SERVICE BULLETIN: JSB 013-1

Date: 8th August 2006

Subject: Jabiru 2200 Engine Rocker Chamber Vent

Figure 1. Vent Position – View Looking Parallel to Valves

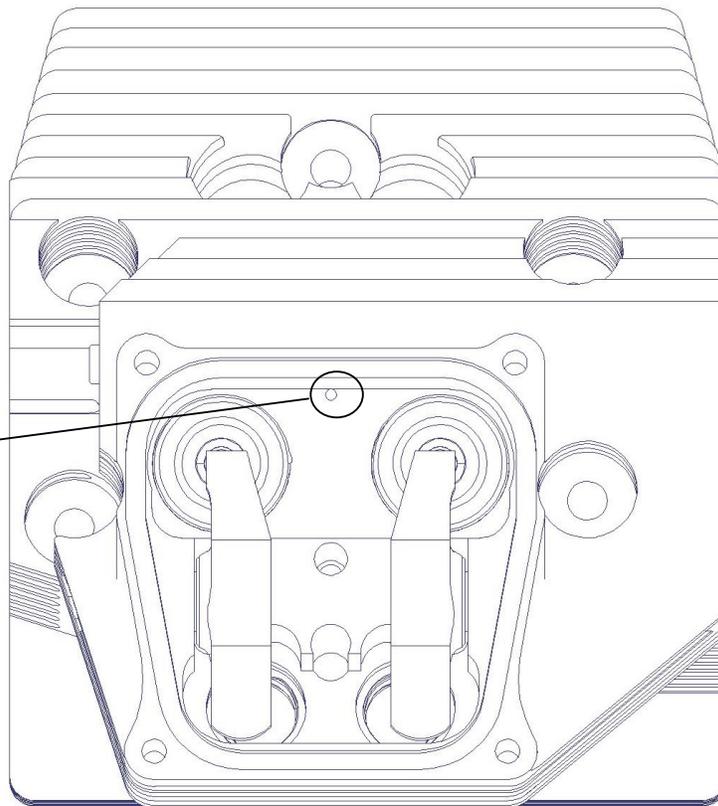
Vent hole
located midway
between valves
at the top of the
rocker cavity.

- i) With reference to the engine's Instruction & Maintenance Manual, remove the aircraft cowls and engine ram-air ducts.
- ii) Remove the rocker covers from the engine.
- iii) Locate the position shown in Figure 2 below and use a small centre punch to mark the hole position.
- iv) Using a 3/32" drill bit, drill a hole in the head as shown. The hole must angle upwards to encourage oil to flow back into the rocker cavity instead of out into the engine bay. Before drilling, coat the tip of the drill bit with grease to catch the aluminium shavings from the hole. Drill in stages, cleaning and re-greasing the drill every second or two. Ensure that no loose shavings escape into the rocker cavity.
- v) Replace the rocker covers re-assemble the aircraft.

Figure 2. Sectioned View of Head Assembly – Hole Shown.

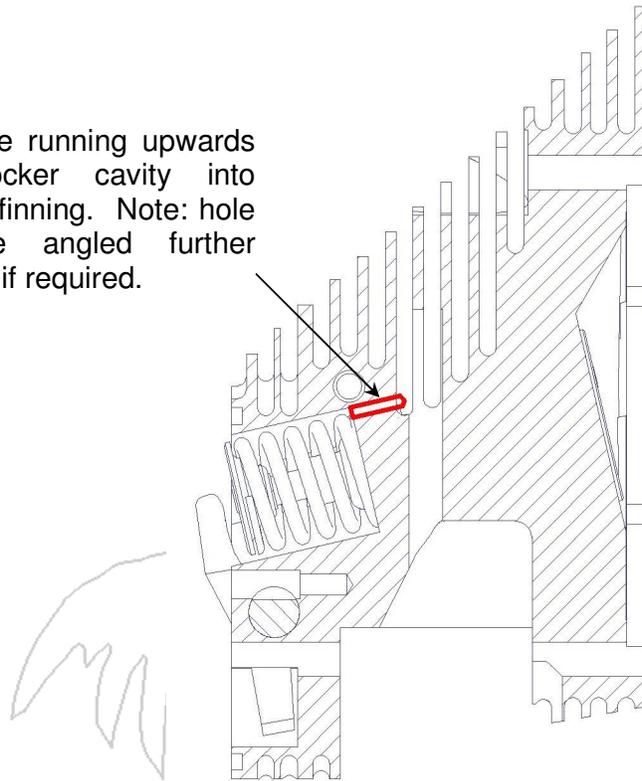
Vent hole running upwards from rocker cavity into external finning. Note: hole may be angled further upwards if required.
